JLRTB02055NAS1

**TECHNICAL BULLETIN**

**SUBJECT/CONCERN:**

Non Start In Cold Ambient Temperatures

**SERVICE INSTRUCTION:****Discovery**

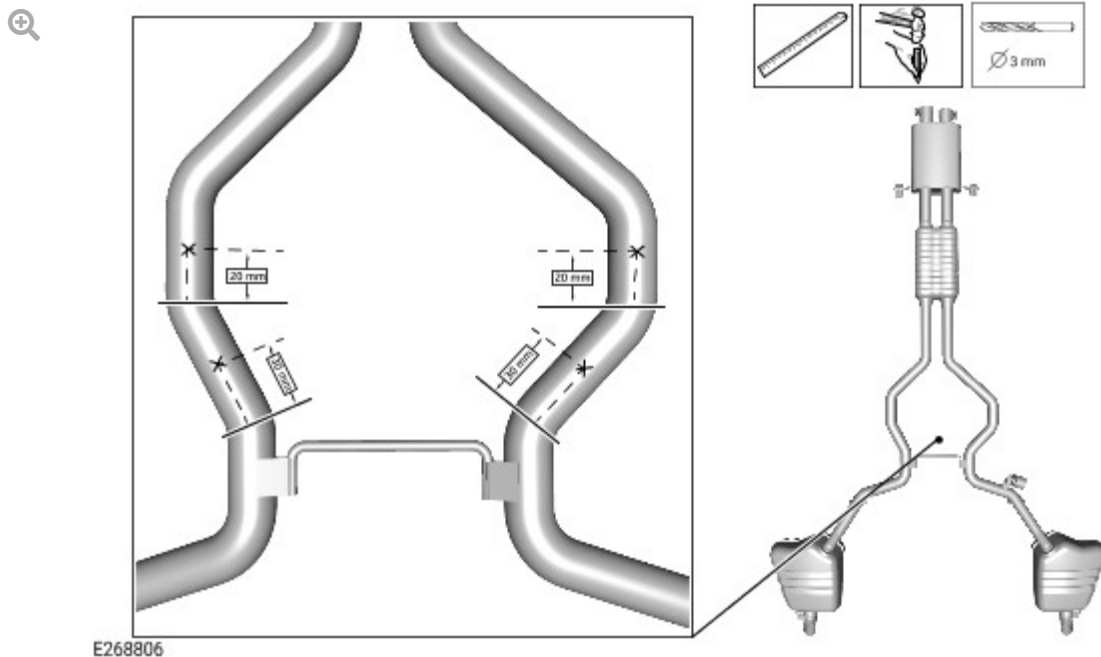
The vehicle will not start after being left over night in cold ambient air temperatures. Further investigation has found high levels of frozen liquid blocking the exhaust system.

Water vapor formation, as a result of normal combustion, is being condensed and frozen over time.

Use a suitable tool to measure each drilling position, shown in the illustration.

- ■ Use a center punch to mark each exact drilling position.
- ■ Slowly drill a 3 mm hole in each position and dispose of any metal filings.
- ■ Allow any liquid to drain out of the exhaust system.
- ■ Use a suitable tool to remove any sharp edges.

## Discovery Sport

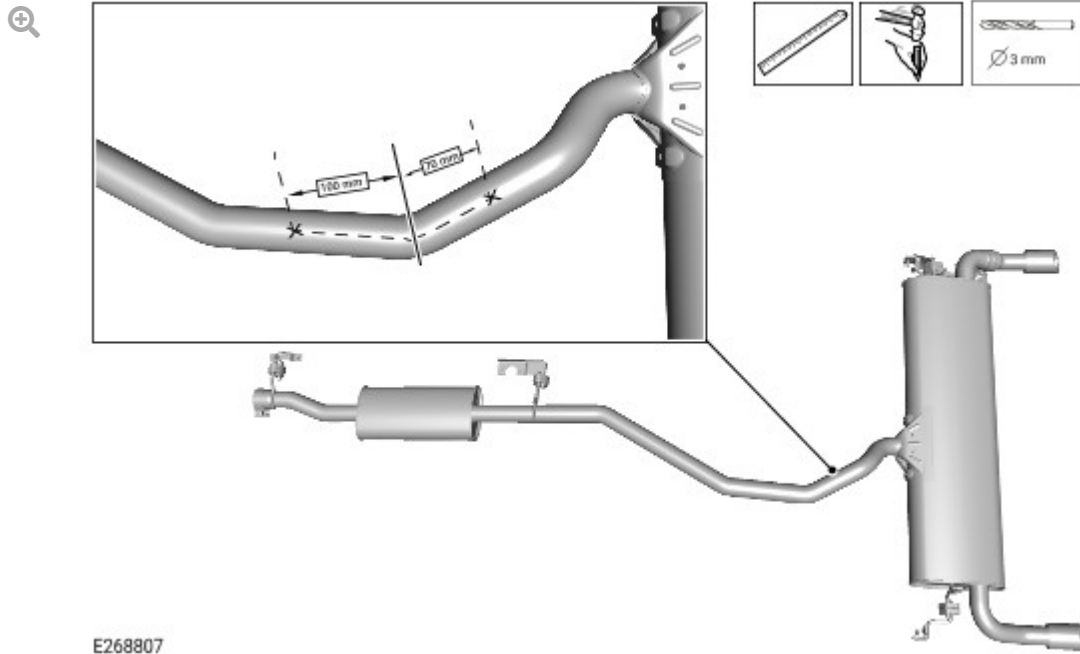
Use a suitable tool to measure each drilling position, shown in the illustration.

- ■ Use a center punch to mark each exact drilling position.
  - ■ Slowly drill a 3 mm hole in each position and dispose of any metal filings.
  - ■ Allow any liquid to drain out of the exhaust system.
  - ■ Use a suitable tool to remove any sharp edges.
- 
6. Lower the vehicle.
